# Service Bulletin

Bulletin No.: 20-NA-079

**Subject: Front Brake Squeal Noise Heard During Light Brake Pedal Application**

6077243

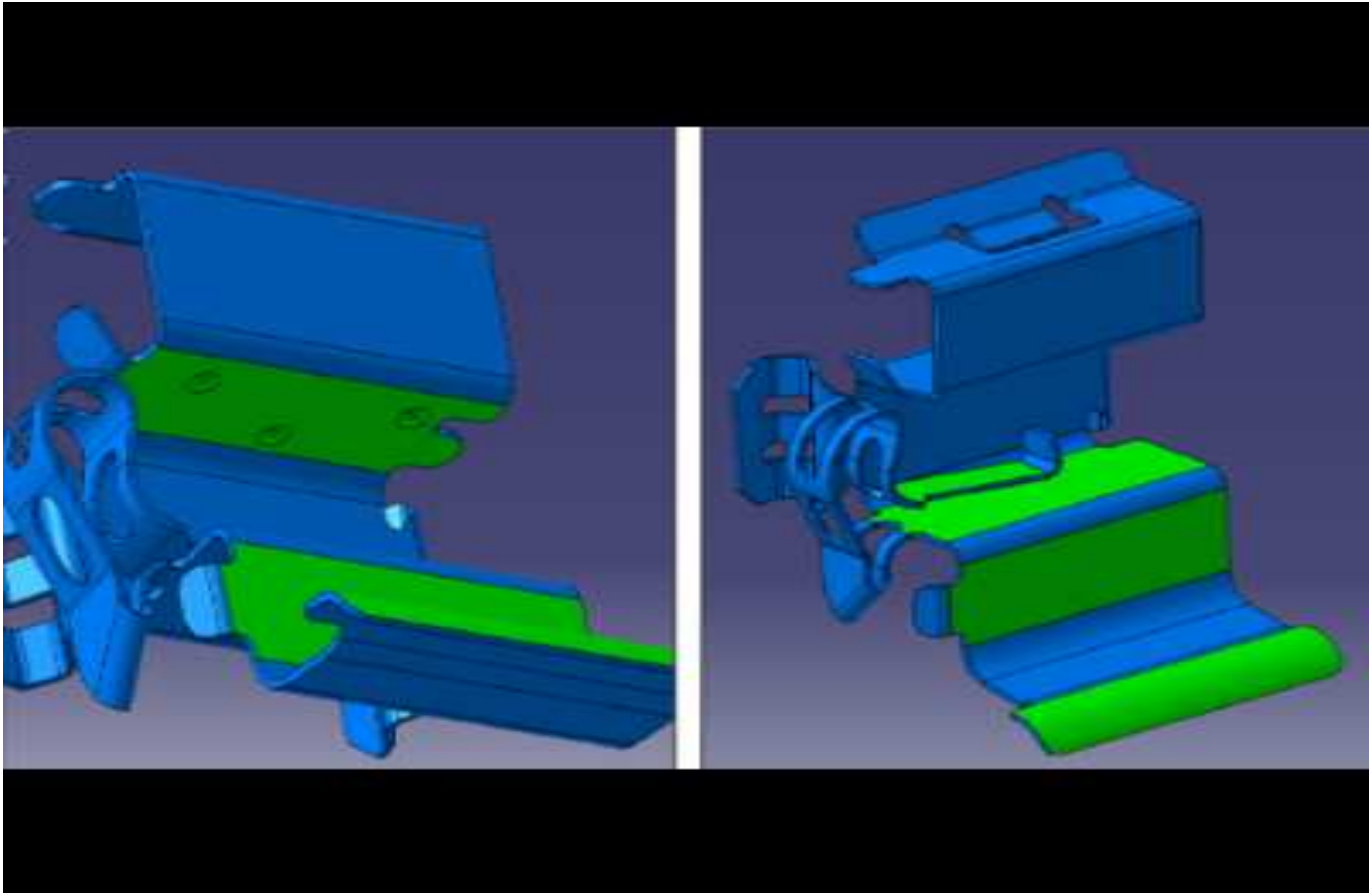
**Note:** There are 4 Pad abutments per caliper.

**Note:** The green area shown above designates the required grease positions.

**Note:** The above graphics are actual grease adding examples.

2. Clean the pad spring abutment area on the caliper and anti-rattle clip.

**Note:** The recommended grease volume is about 1.1 g per caliper.

3. Apply Molykote M-77 Grease (GM P/N 19356408) on caliper pad spring abutment and clip as shown in the graphic above.
4. Install new front brake disc pads and sensors (if equipped). Refer to *Front Disc Brake Pads Replacement* in the Service Manual.
5. Verify brake noise has been eliminated.
